NO: CON-019      PRODUCT: XS2F, XS2W Connector Cordset  
 DATE: November 2015      TYPE: Modification Notice

## XS2F/XS2W 4-pin Cordsets Modified with 5-pin Connectors; 5-pin Cordsets Modified to Prevent Loose Connections

Effective Date: November 1, 2015 production

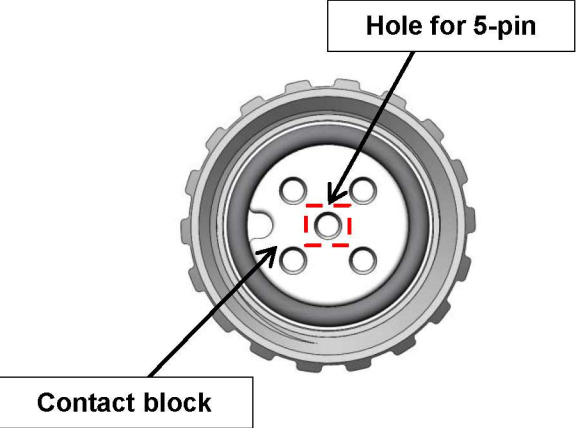
For 4-pin connector cordsets, they will be able to accept a 5-pin plug connector to mate with the 4-pin socket connector.

#### 4-pin Cordsets Modified with 5-pin Sockets

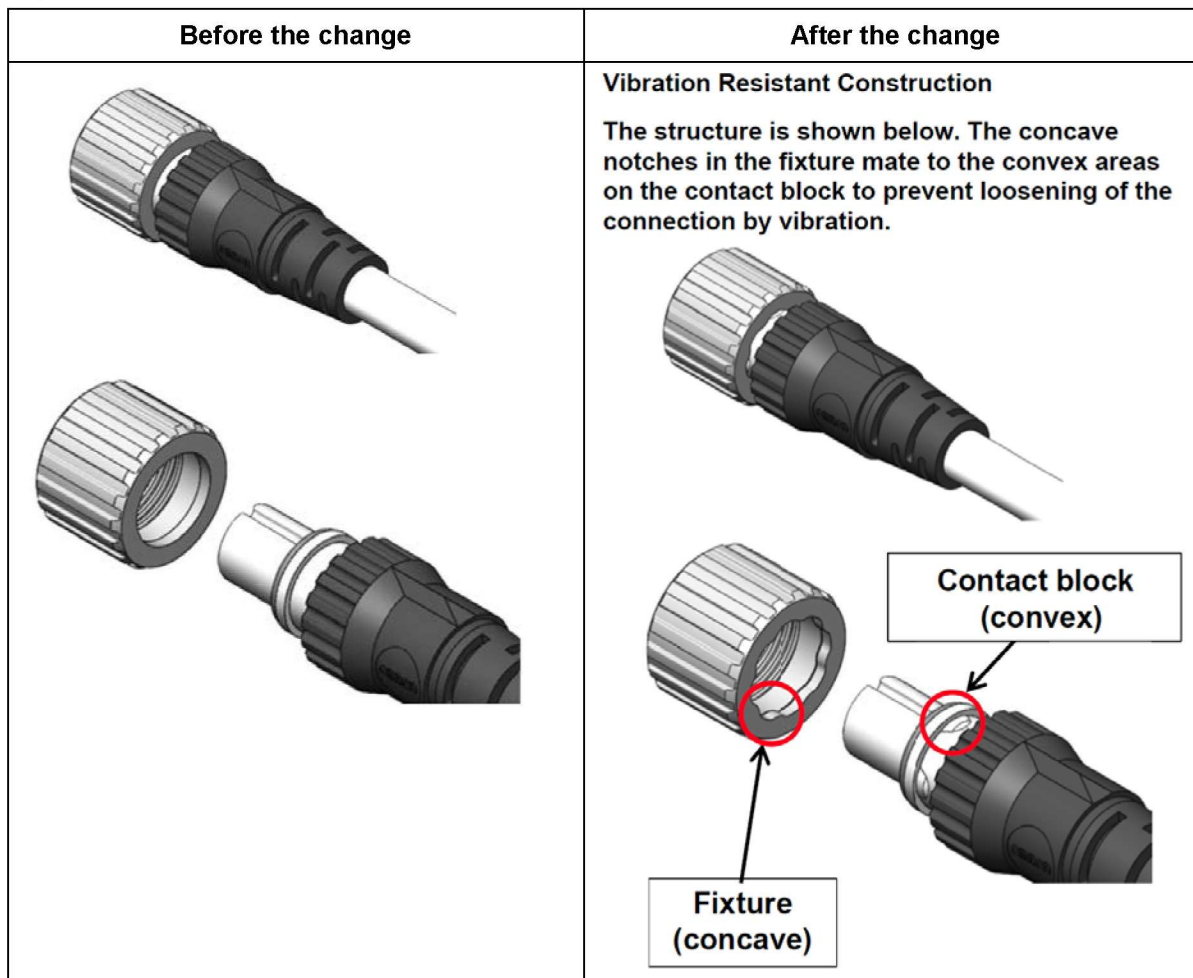
For 5-pin connector cordsets, socket construction was modified with notches to prevent vibration from loosening the connection. This construction was already applied to 3-pin and 4-pin cordset connectors.

Before the change	After the change
	<p data-bbox="803 1096 1393 1186">There is now a hole in the center of the contact block so a 5-pin plug connector can be mated with a 4-pin socket connector.</p>
